REGULATORY INFORMATION DISTRIBUTION SYSTEM (RIDS)

SUBJECT: Responds to NRC 940315 ltr re violation noted in Insp Rept
 50-397/94-02. Corrective actions: Surveillance Procedure
 (PPM 7.4.6.1.2) changed to include independent verification
 of EFCV bypass valve closure for listed valves.

Subject: **WNP-2, OPERATING LICENSE NO. NPF-21**
NRC INSPECTION REPORT 94-02 REPLY TO A NOTICE OF VIOLATION

Figure 1.
EFCVs inside containment
Functional Diagram

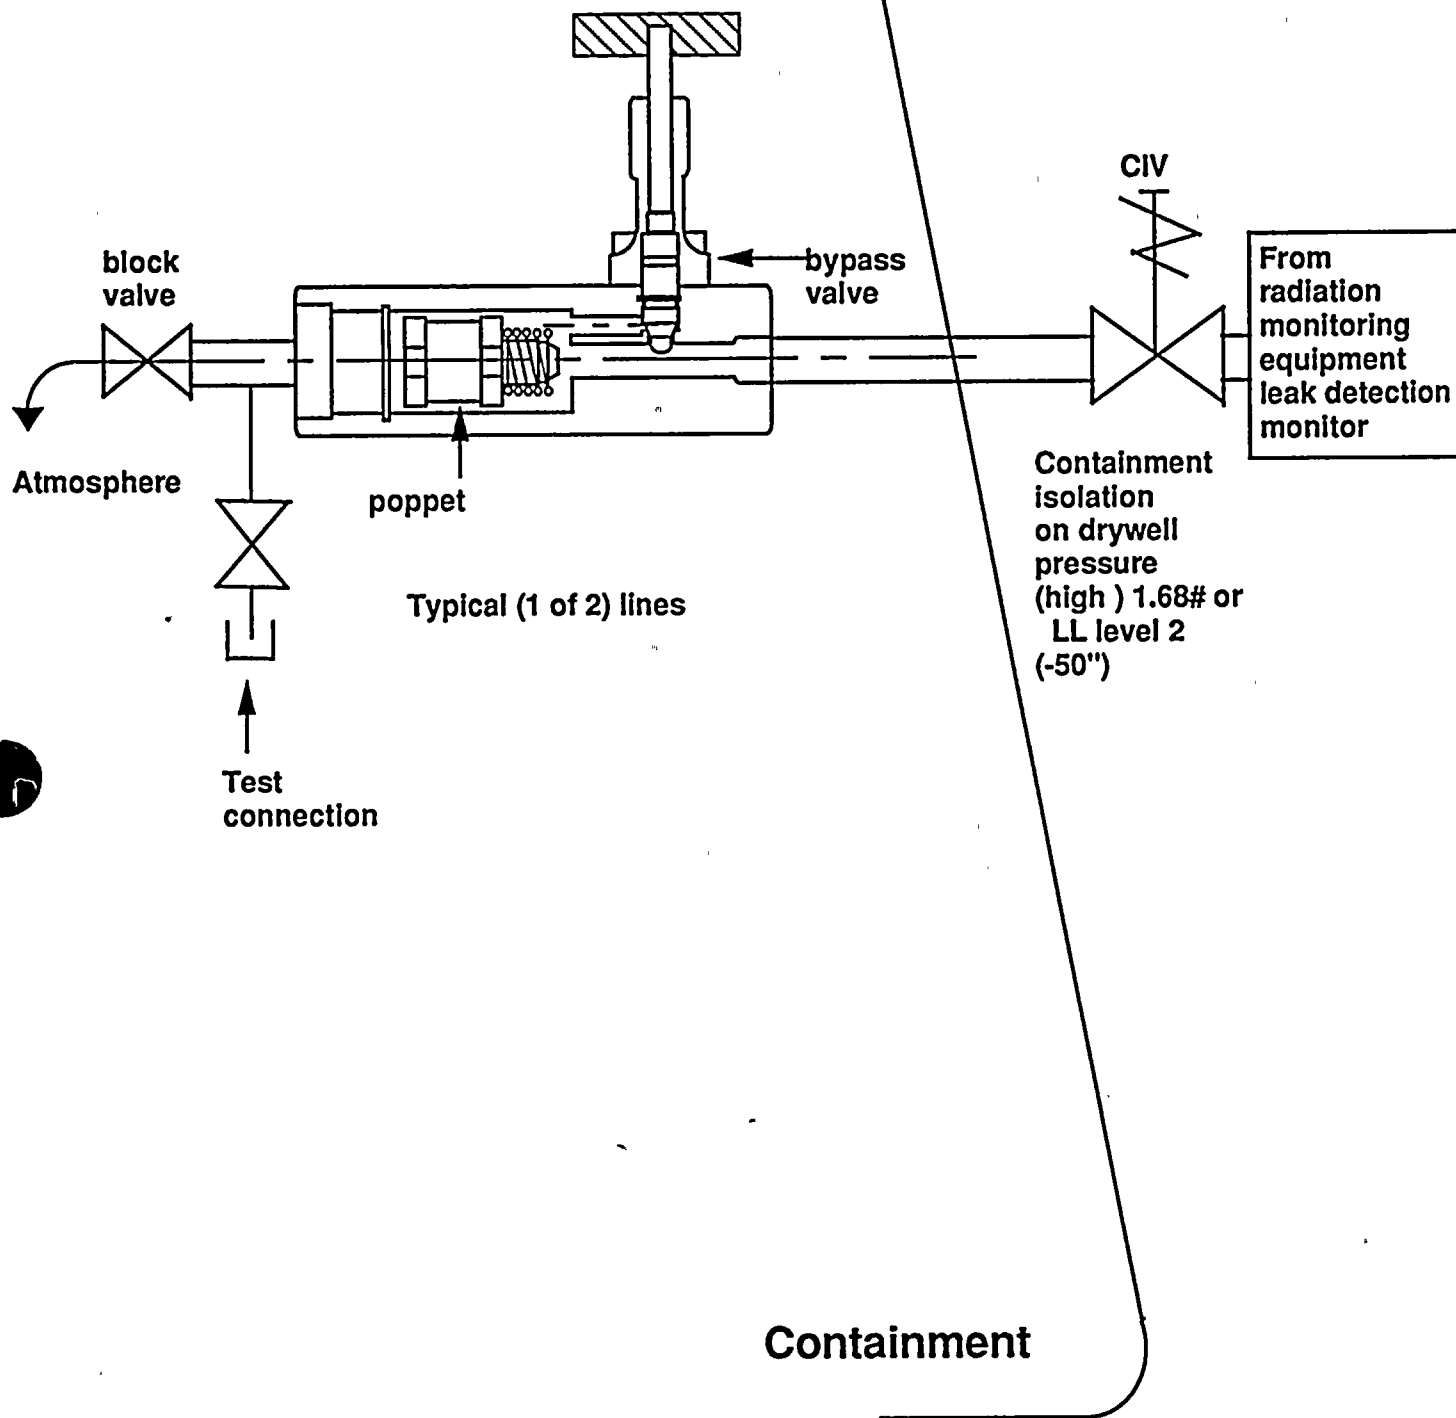
A review of the implementing procedure identified a discrepancy which resulted in noncompliance with Technical Specification 4.6.1.1.b requirements. The EFCV bypass valves were not verified closed because the procedure did not provide accurate guidance to

successfully meet the requirement. Specifically, the EFCV bypass valves were identified by incorrect EPNs (equipment piece numbers). Due to this procedure error, a potential exists that verification of closure was made of a normally closed drain/test connection, rather than the EFCV bypass valve (Figure 1). However, the EFCVs are verified closed as part of two other surveillance procedures, the Local Leak Rate Testing (LLRT) and Inservice Testing (IST). The IST was performed most recently on May 27, 1993 and satisfies Technical Specification 4.6.1.1.b for the time period up to April 1994, when the plant was shut down for the maintenance and refueling outage.

The surveillance procedure (PPM 7.4.6.1.2) has been changed to include independent verification of EFCV bypass valve closure for valves PI-EFC-X72f and PI-EFC-X73e.

Figure 2.
EFCVs Inside containment

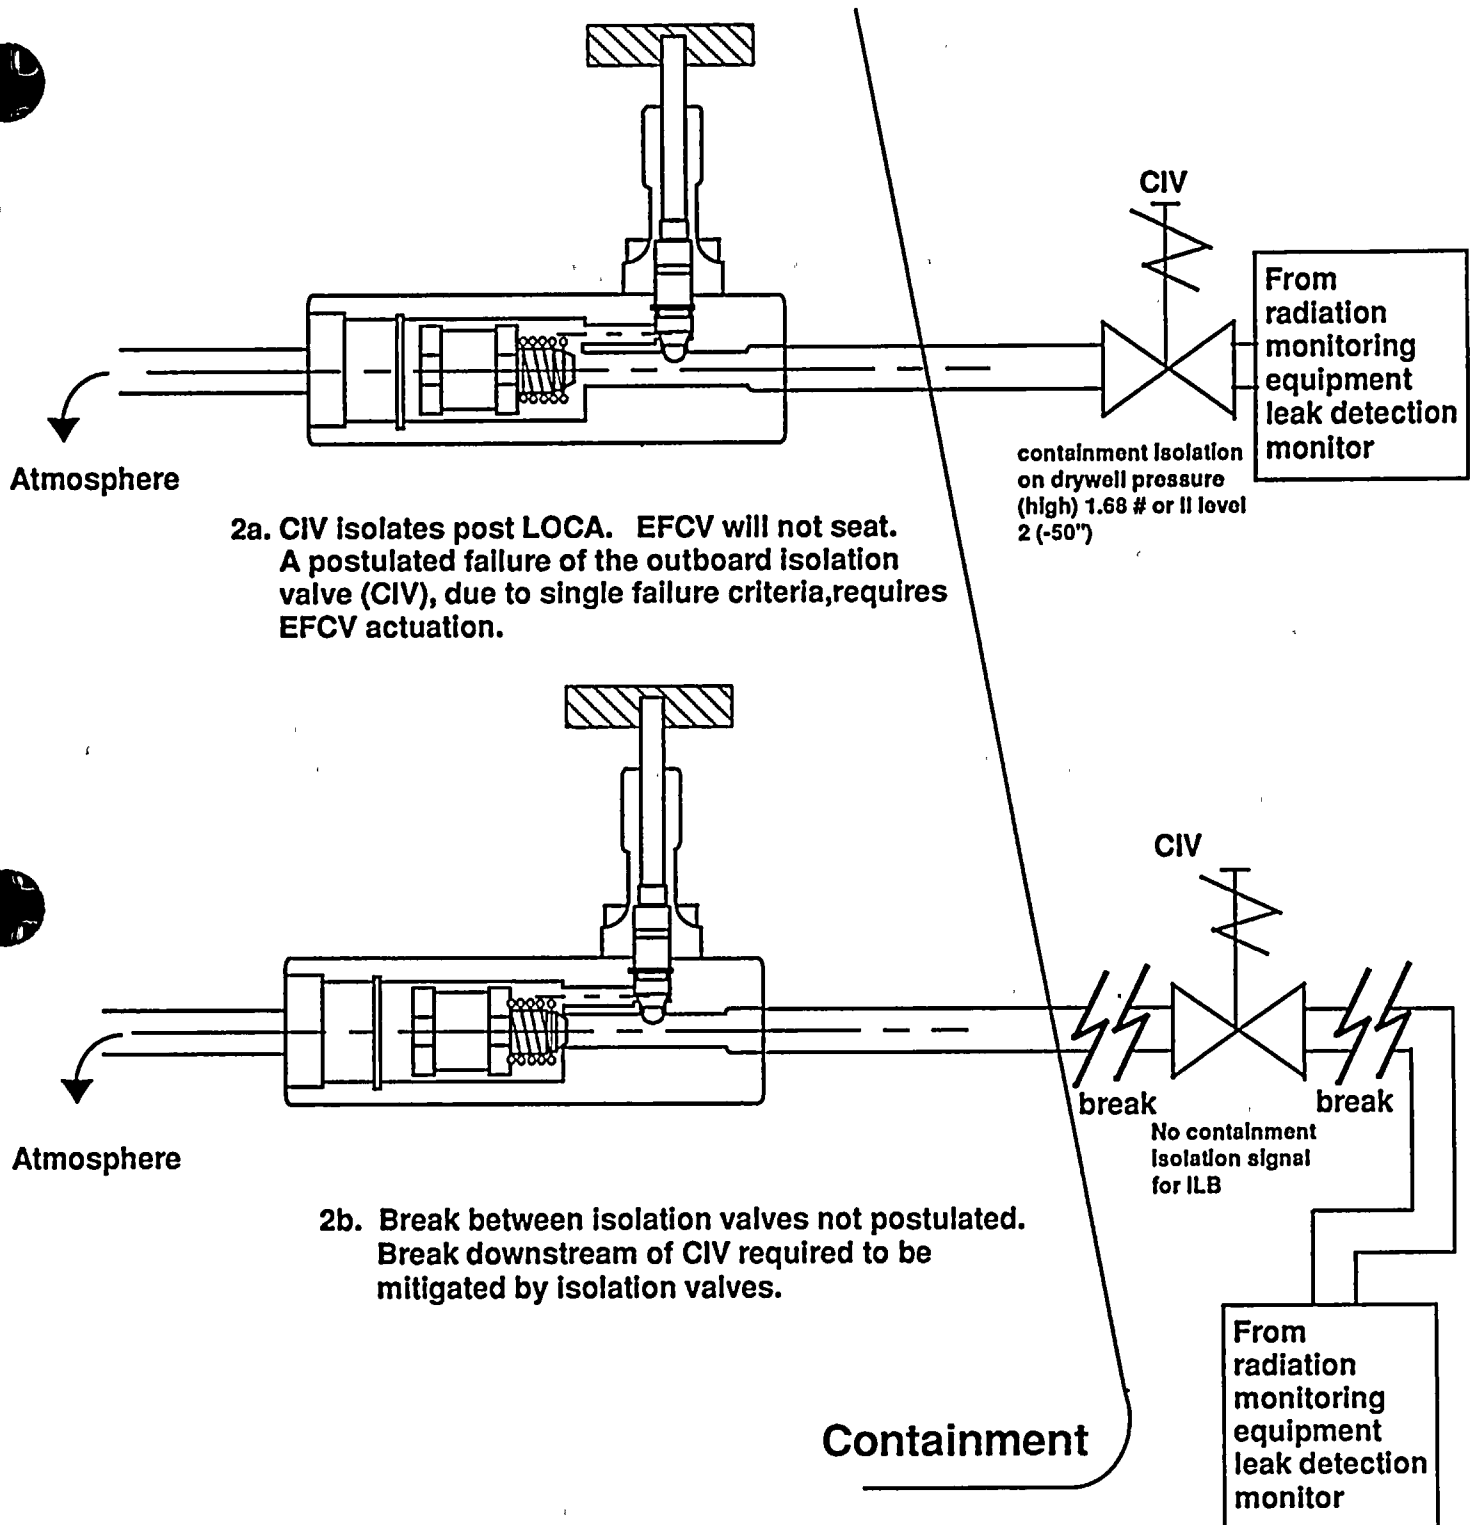
The EFCVs inside containment are one of two required isolation valves on radiation monitor return lines. These lines are capable of being closed by operable containment automatic isolation solenoid valves located outside containment (Figure 2a). The EFCVs do not have restrictive orifices and are not installed on instrument lines. Regulatory Guide (RG) 1.11, "Instrument Lines Penetrating Primary Reactor Containment", does not apply to these EFCVs. The EFCVs inside containment provide no instrument line break (ILB) mitigation function (Figure 2b).

During the course of this evaluation an additional problem was identified. This was a design error which is postulated to degrade the containment isolation capability of PI-EFC-X72f and PI-EFC-X73e. Specifically, the EFCVs are spring loaded in the open position. For the design basis LOCA, containment pressure post LOCA will seat these valves and provide containment isolation. A decrease in containment pressure will permit these to re-open, degrading the containment isolation capability of these inboard isolation valves. These two EFCVs have been declared inoperable. The associated penetrations were isolated on April 20, 1994 per Technical Specification requirements. This concern will be discussed in detail in a future Licensee Event Report.

Figure 3.
EFCVs outside containment LOCA mitigation

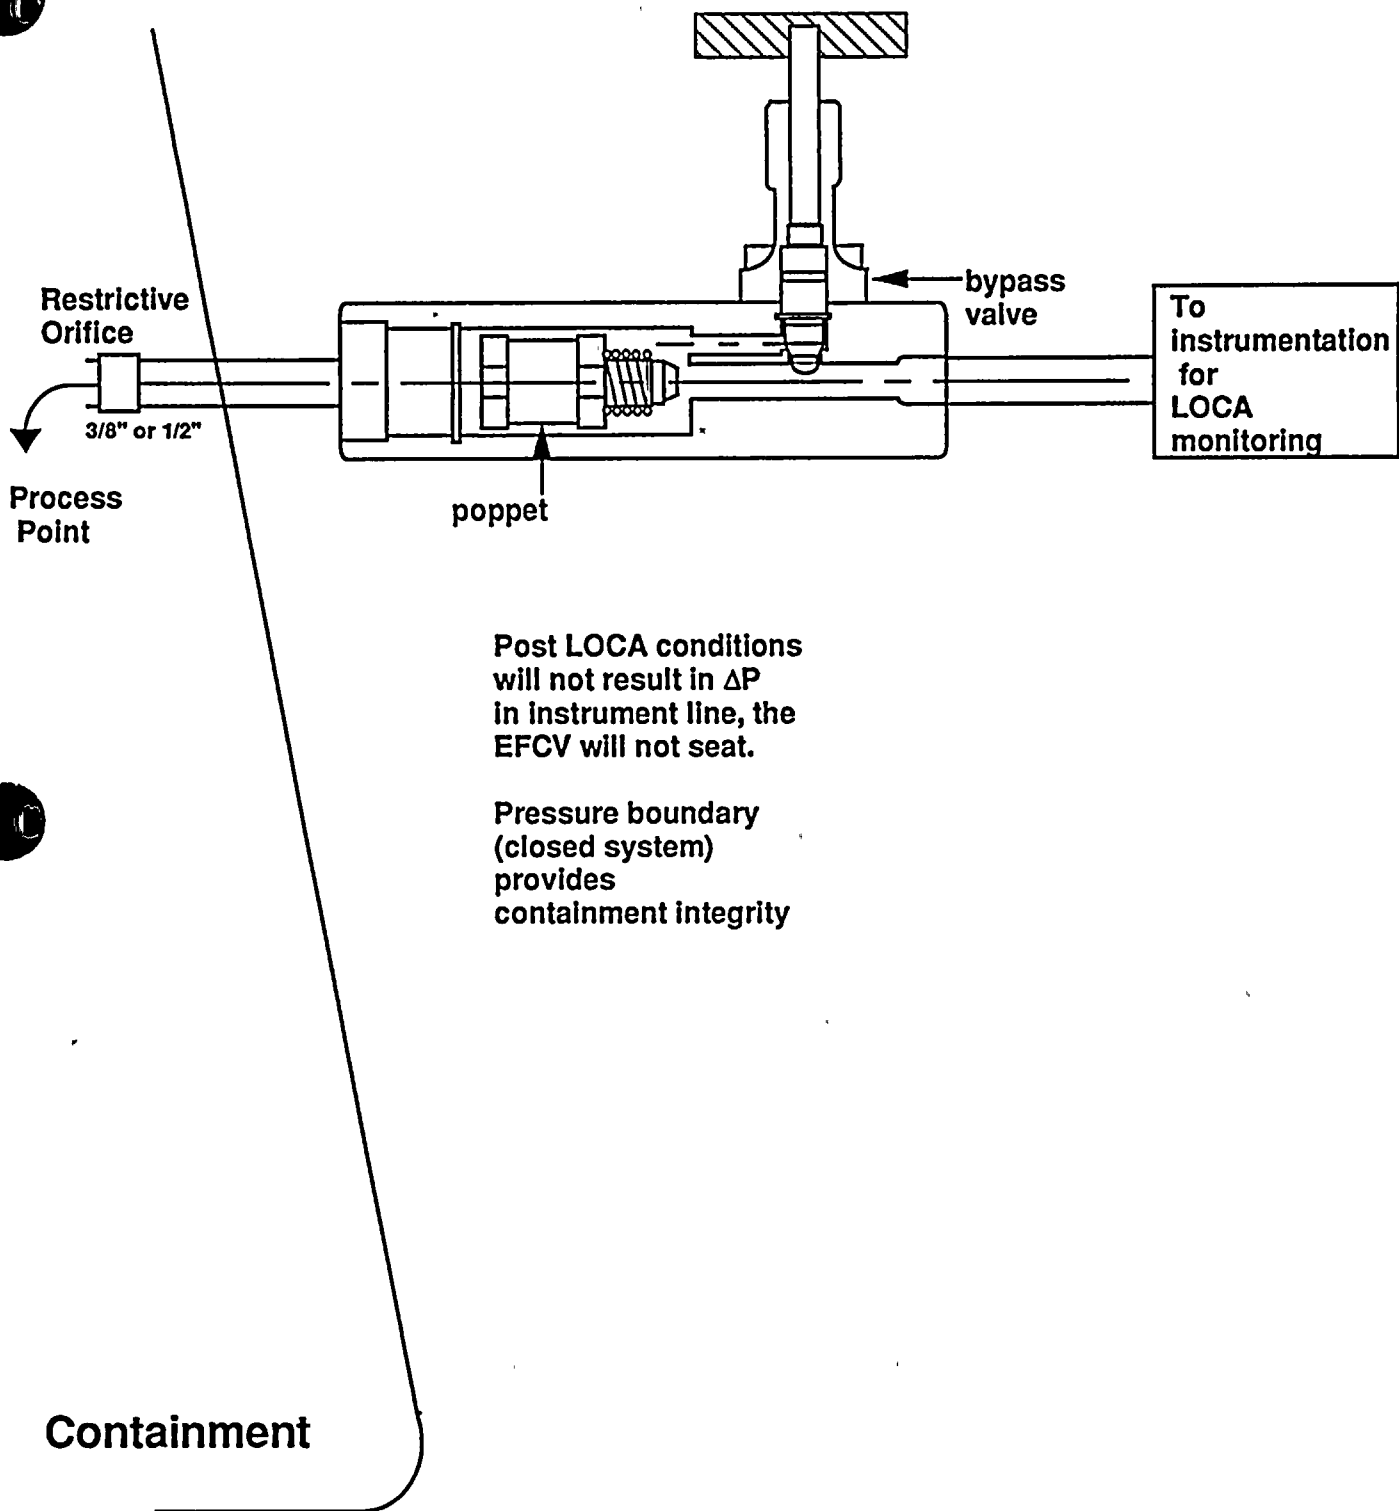
Technical Specification 4.6.1.1.b does not apply to the 113 EFCVs outside of containment because they provide no active containment integrity function to mitigate the consequences of a LOCA (Figure 3). The penetrations served by these EFCVs are not required to be closed during accident conditions for which primary containment integrity is required. For the LOCA, the EFCVs must remain open to allow instrumentation outside containment to perform the required post-LOCA monitoring functions. The EFCVs, therefore, provide a passive pressure boundary function which is ensured by valve, instrument, and piping design of the same quality standards as the containment. The instruments and piping maintain this containment integrity function with the EFCVs in the open position.

Figure 4.
EFCVs outside containment
instrument line break (ILB) mitigation

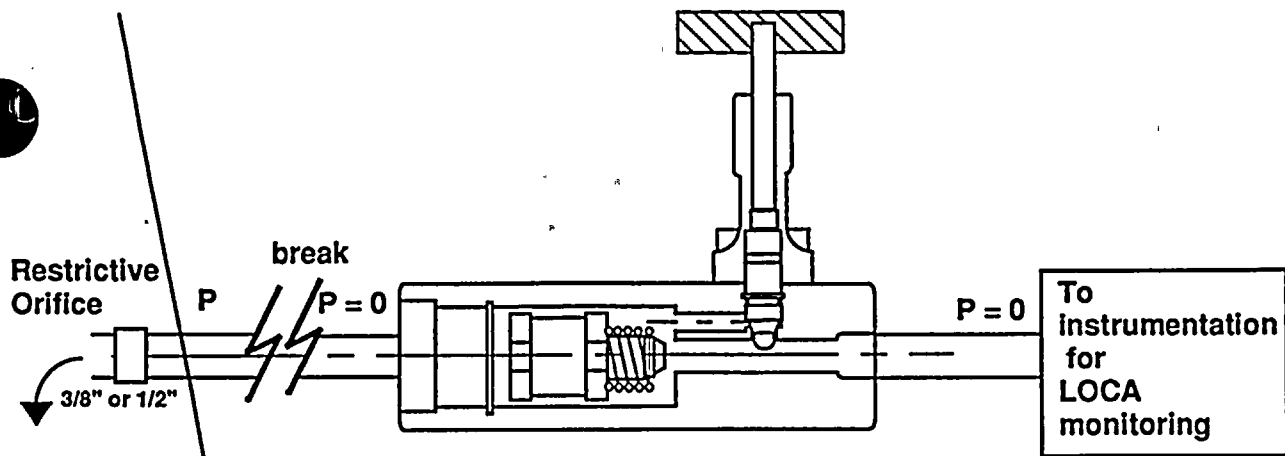
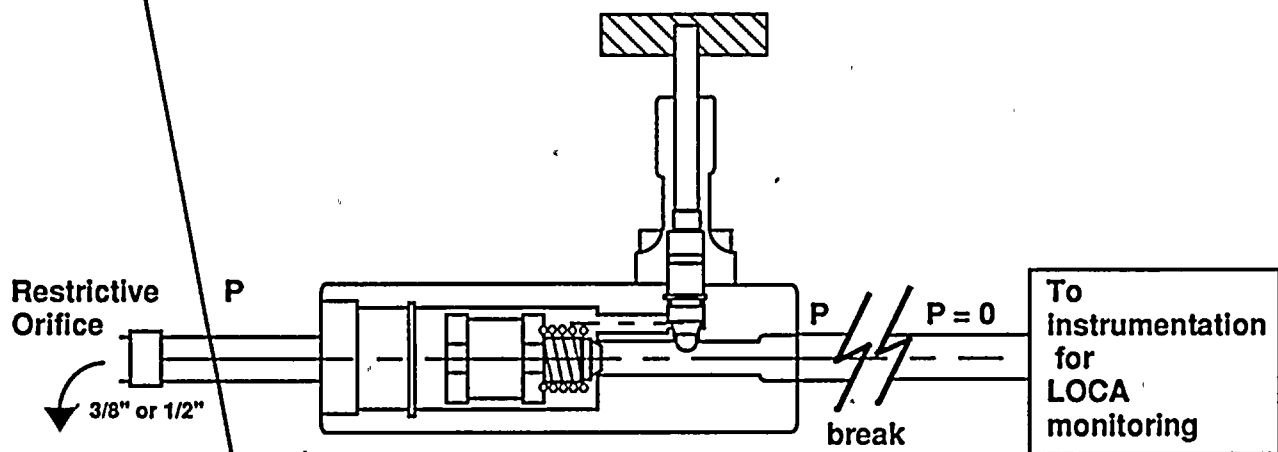
EFCVs outside containment mitigate an ILB as described in FSAR Chapter 15.6.2. Although these EFCVs will isolate an ILB downstream of the EFCV, no credit is taken for automatic closure in the accident analyses (Figure 4).

4a. No ΔP across EFCV, no automatic ILB isolation.
must de-pressurize RPV to mitigate event.

4b. ΔP will seat EFCV, ILB isolation.
